WNI-32 NCE Pro Cab Wi-Fi Interface Module

Compatibility, Firmware Issues and Workarounds

WifiTrax Model Science

Technical Note on Intermittent Power-up via Red Button on Pro Cab

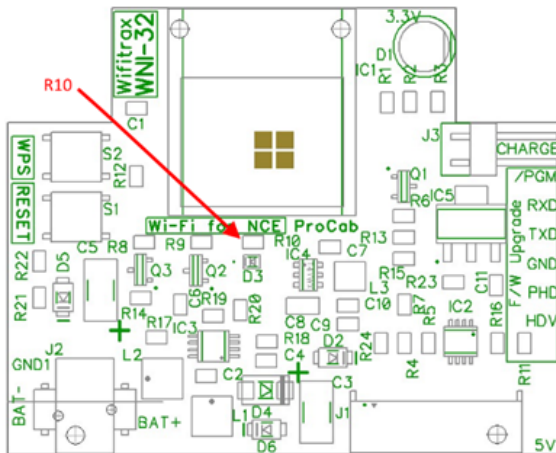
The WNI-32 supplies 5V battery voltage through one of the wake-up lines and expects that to be fed back through the other wake-up line when the button is pressed. The 5V is supplied through a 10K resistor (R10) on the WNI-32.

One of the other two patterns of gold fingers is connected to an output of a CMOS 3 to 8 decoder chip (74HC138B) which is unpowered at the time power-up is attempted. The 4th gold finger pattern has no effect.

If pressing the red button results in the 3rd gold finger pattern to make contact with the two wake-up patterns, the result is that current from the WNI-32 flows through protection diodes on the output of the 74HC138B to its 5V power and thus reduces the voltage feeding back to the WNI-32 to about 1.5V which is not enough to enable the SEPIC converter.

So it turns on if the red button conductive coating does NOT contact that 3rd gold finger going to the decoder, even if only momentarily, to give it a chance to power up.

The issue can be fixed by replacing the 10K resistor R10 with a 1K resistor which fixes the problem as it allows current to flow through the protection diode pathway described and yet still maintain enough voltage fed back to the WNI-32 to cause successful power up.

Under the fix, the current flowing through the protection diodes of the decoder is still well within the specified limits for that chip (74HC138B), so there will be no chance of damage to the 74HC138B.

So the fix is to change R10 on the WNI-32 from 10K Ohm to 1K Ohm. The recommended component is RC0805FR-071KL, a Yageo component. This is a 1/8 Watt, 1%, 0805 resistor (0.08 inch x 0.05 inch). Any equivalent resistor will be acceptable.
